AMENDMENTS TO THE DRAWINGS:

REMARKS

ANNOTATED SHEET SHOWING CHANGES

FIG. 1

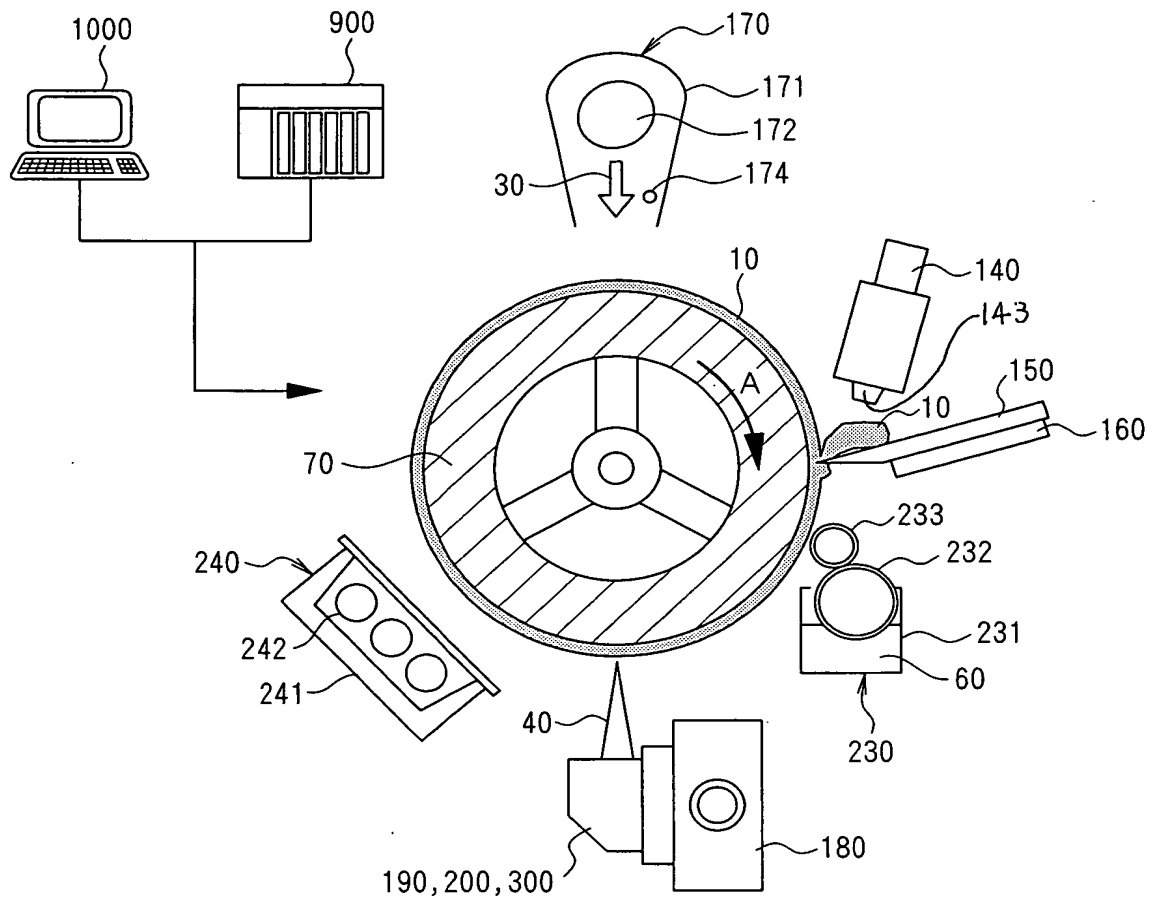
Also, enclosed are Annotated and Replacement Drawings of Figs. 1-3 that include the reference numerals added to page 32. These reference numerals are numerals 71 and 72 in Fig. 2 and numeral 143 in Figs. 1 and 3. No new matter is being added by these amendments and their entry is therefore requested.
